Response to LHA consultation report

Land at Penllergaer Business Park

Project/File:
35251-HYD-XX-XX-RP-TP-1002-P03

This Technical Note has been prepared by Stantec on behalf of Stoford Properties Ltd following the Local Highway Authority (LHA) consultation response received on 19th January 2026 in relation to planning application 2025/2027/FUL.

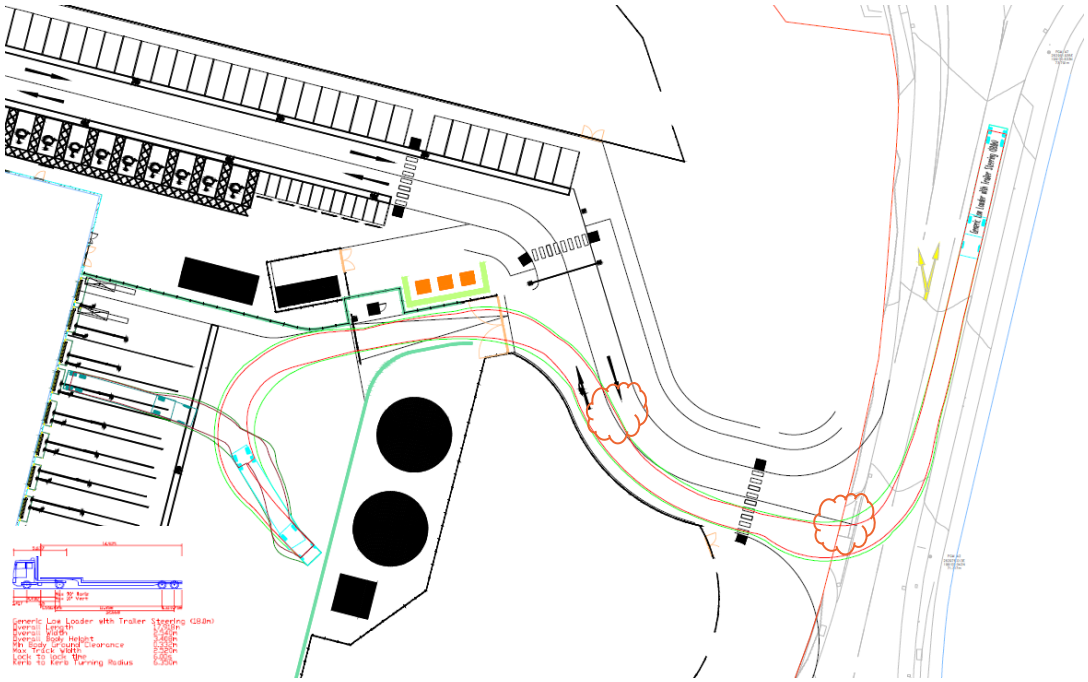
- **Swept path analysis:** A review of the 18m articulated vehicle tracking indicates that a larger HGV cannot access the distribution warehouse loading bay without significant encroachment into adjacent carriageways on two occasions.
- **Parking:** LHA currently considers the parking strategy presented within the application to be inconsistent with adopted planning policy and therefore non-compliant with SPG requirements.
- **Site access / Section 278 works:** including the design of S278 works, HGV manoeuvres, provision of a zebra crossing on the minor arm of the proposed Heol Y Ddraig access junction.

The drawing submitted at planning shows a minor body overhang onto the adjacent carriageway at the Heol Y Ddraig access junction, and onto the opposing carriageway when manoeuvring into the loading bay access gate, as shown in Figure 2-1 below.

The swept paths analysis has been updated to show that the 18m articulated vehicle can safely access the development site without any body overhang onto the adjacent carriageway at the Heol Y Ddraig access junction, and onto the opposing carriageway when manoeuvring into the loading bay access gate. This is shown in Figure 2-2 below, and presented in full in Appendix B.

Figure 4-1 Dropped kerbs and tactile paving along the main pedestrian desire lines

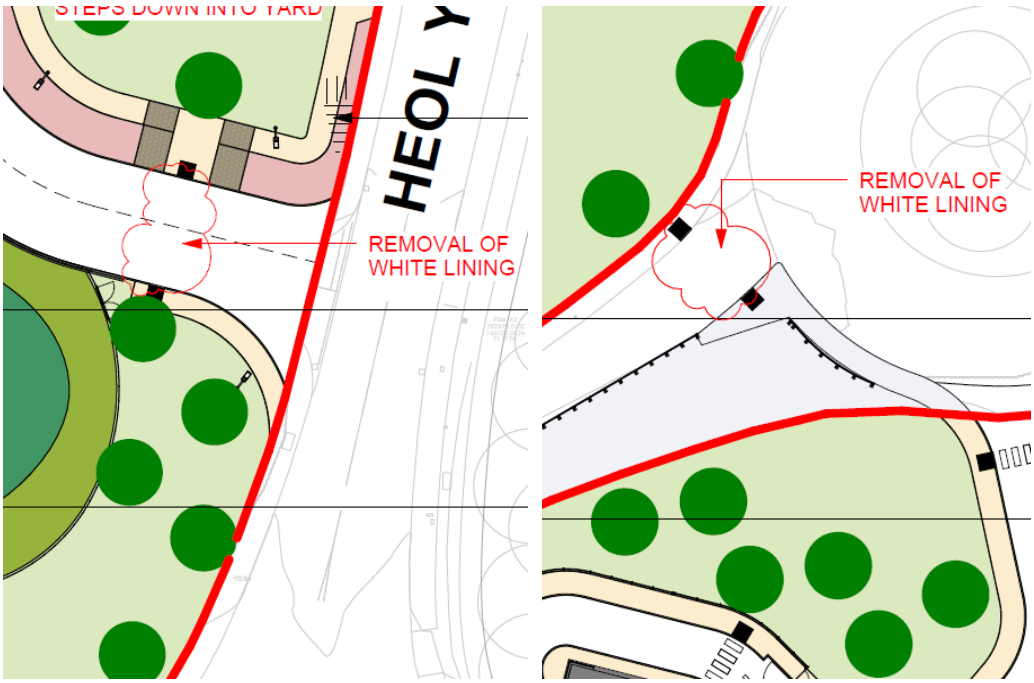
> *"the proposed layout for the Heol Y Ddraig access junction includes a zebra crossing on the minor arm, positioned slightly offset from the main road. While the intention to prioritise pedestrians aligns with Welsh Government's hierarchy of road users, the LHA considers its inclusion inappropriate in this instance. The risk of vehicles stopping abruptly within the junction area could lead to obstruction of traffic on the main road. Instead, the crossing should be replaced with an uncontrolled crossing point incorporating dropped kerbs and tactile paving, located along the pedestrian desire line and designed in accordance with the latest guidance."*

The layout has since been updated which includes the removal of the zebra crossing point and the provision of an uncontrolled crossing point incorporating dropped kerbs and tactile paving. The provision of dropped kerbs and tactile paving along the main pedestrian desire lines is shown in Figure 4-1 below and presented in full in Appendix D.

The zebra crossing points have been replaced with an uncontrolled crossing point incorporating dropped kerbs and tactile paving, located along the pedestrian desire line and designed in accordance with the latest guidance.

Figure 6-1 Mitigation Measures M4 Junction 47-A48: Option B

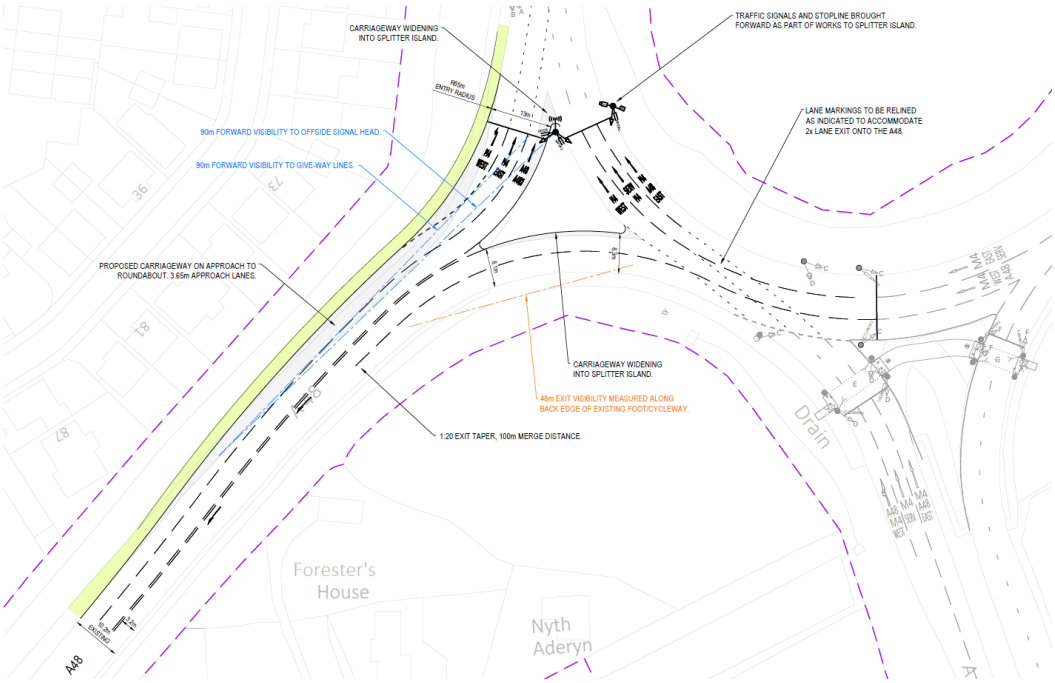
> *"The reliance on reinstating a measure that was previously trialled and proven unsuccessful as the sole mitigation strategy to offset the development's transport impacts raises significant safety concerns".*

Therefore, an alternative arrangement has been presented to the LHA which consists of carriageway widening primarily from the northern side of the A48, with localised widening into the splitter island, to provide a longer merge length and improved taper from the roundabout junction. These Option B mitigation works are shown in Figure 6-1 below, and presented in full in Appendix F.

This design removes the need for a zipper merge arrangement and provides a sufficient taper length for vehicles to safely exit the roundabout, increasing the merge length where two lanes converge.

SKETCH PLAN - J47 A48 IMPROVEMENTS OPTION B OVERLAY

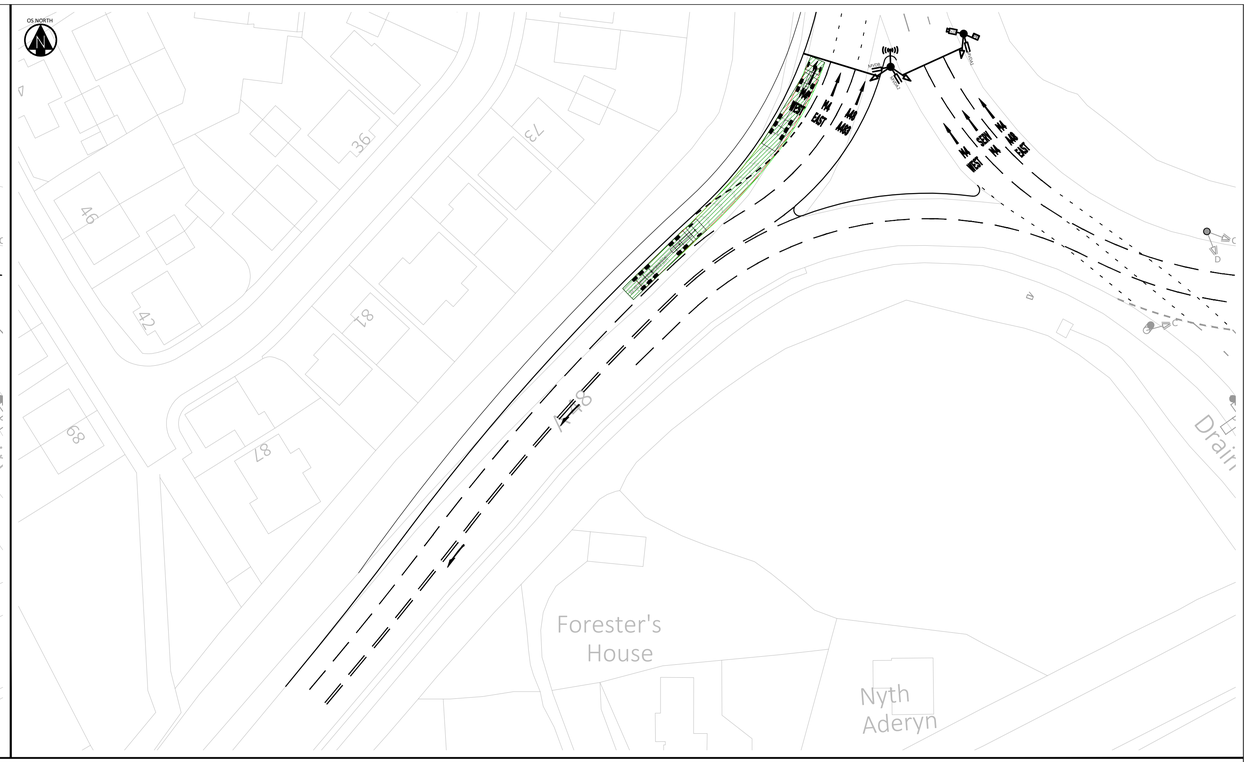
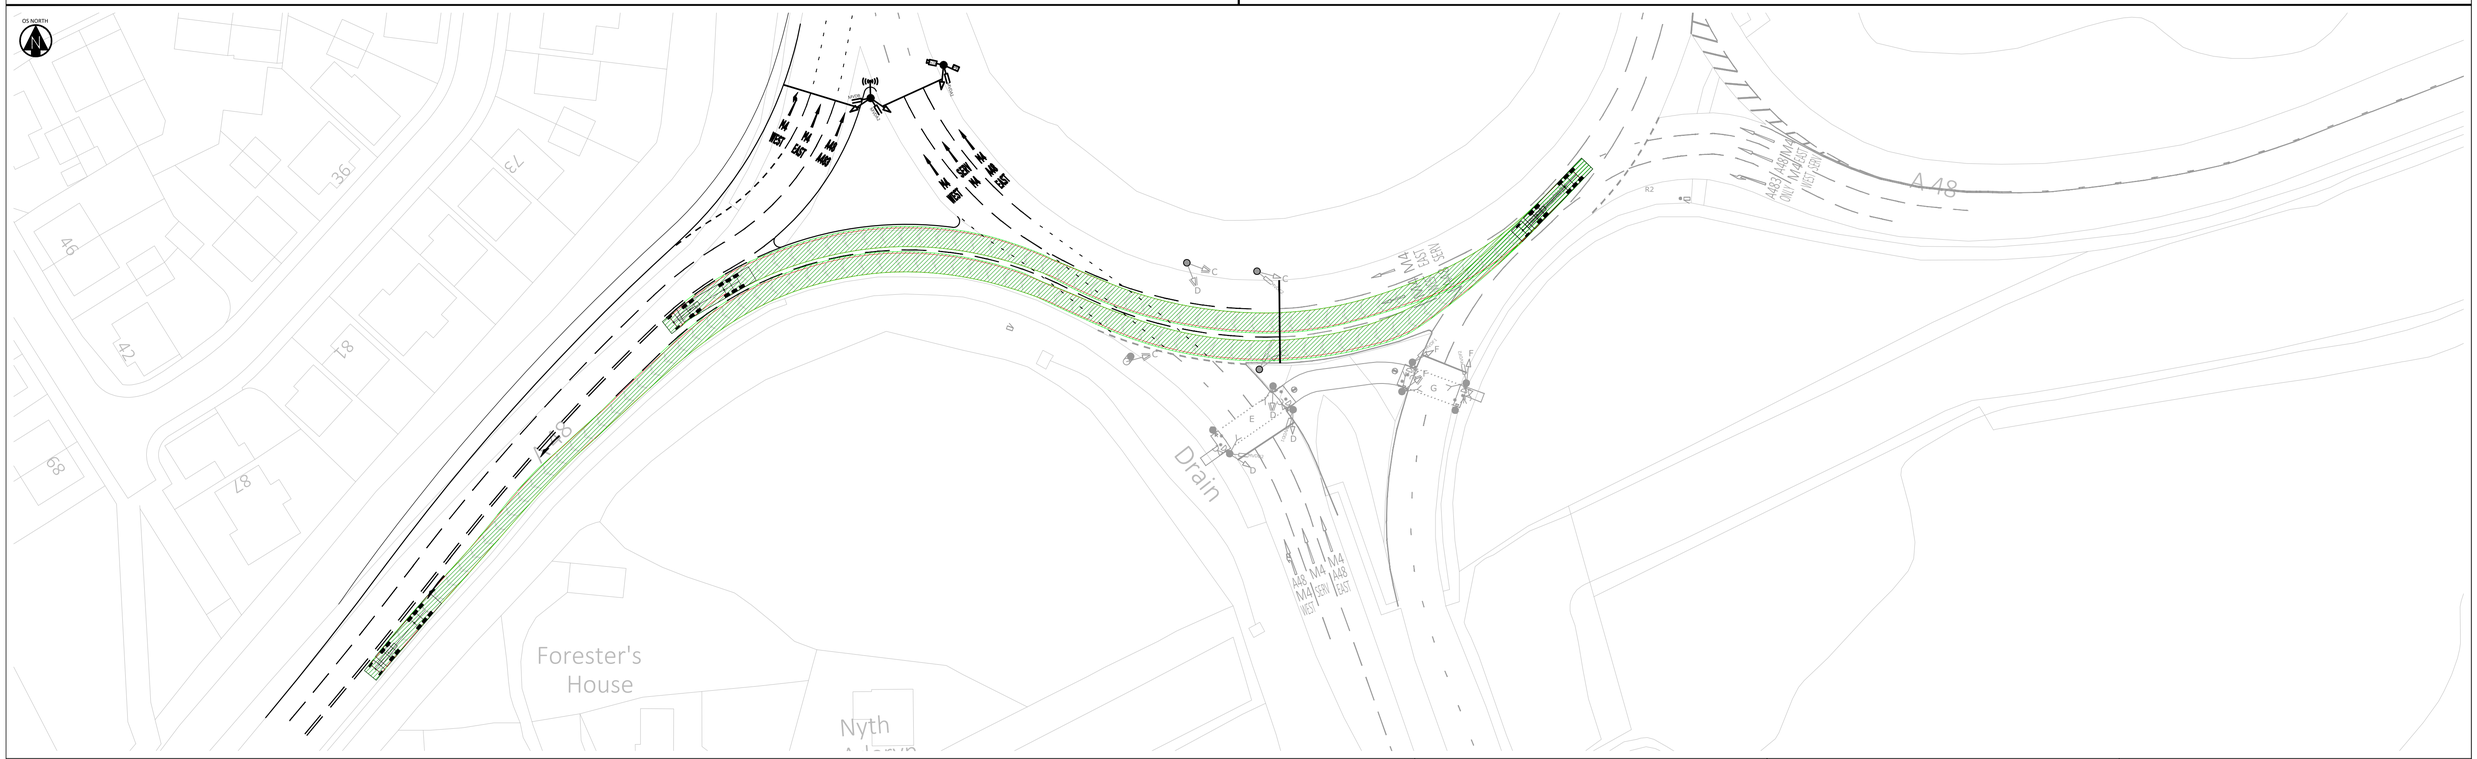
The reliance on reinstating a measure that was previously trialled and proven unsuccessful as the sole mitigation strategy to offset the development's transport impacts raises significant safety concerns. Throughout the planning process, the Local Highway Authority (LHA) has consistently maintained that a merge exit from the
